Theatre Salina Expansion – Proj #22-3239

ADDENDUM NO. 4

THEATRE SALINA
DANCE STUDIOS & SCENE SHOP EXPANSION
SALINA, KANSAS

COPYRIGHT ©

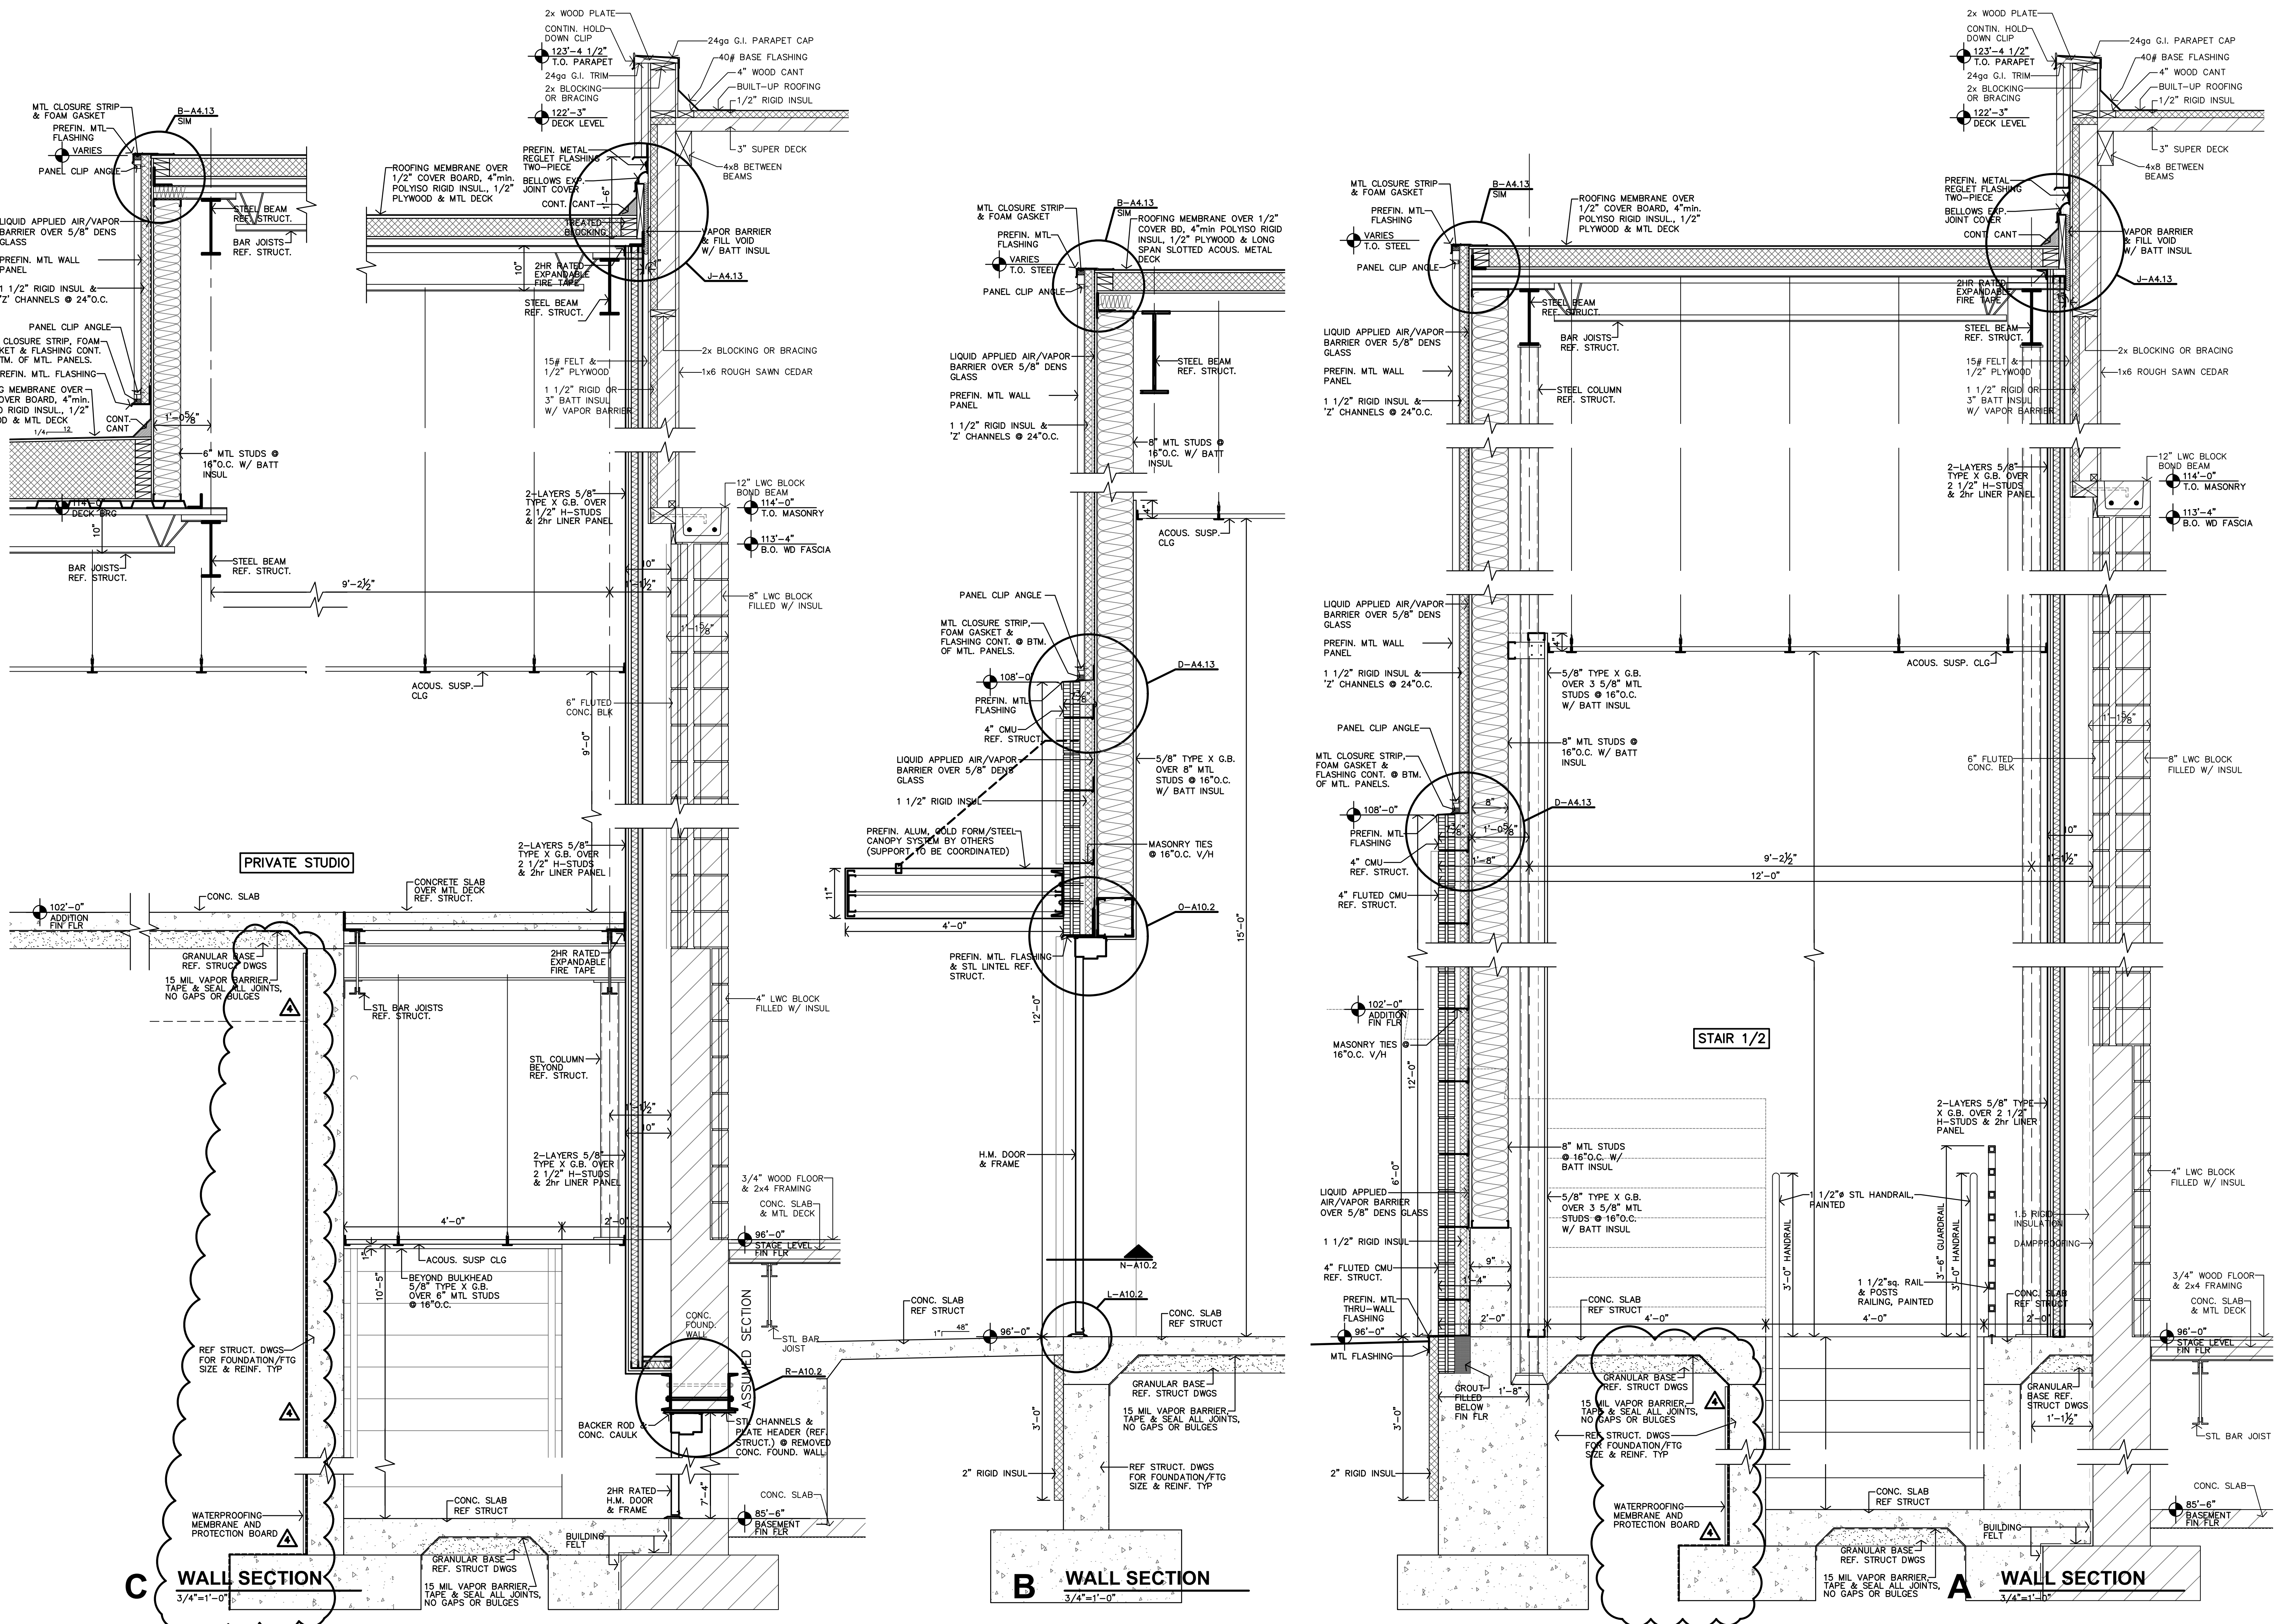
3. Sheet A4.5 and A4.6 Wall sections - Clarification, all new walls exposed to basement areas, including Stairs S1/S2 shall be waterproofed with membrane waterproofing and protection board per specifications. Reference the attached revised sheet A4.5 and A4.6.
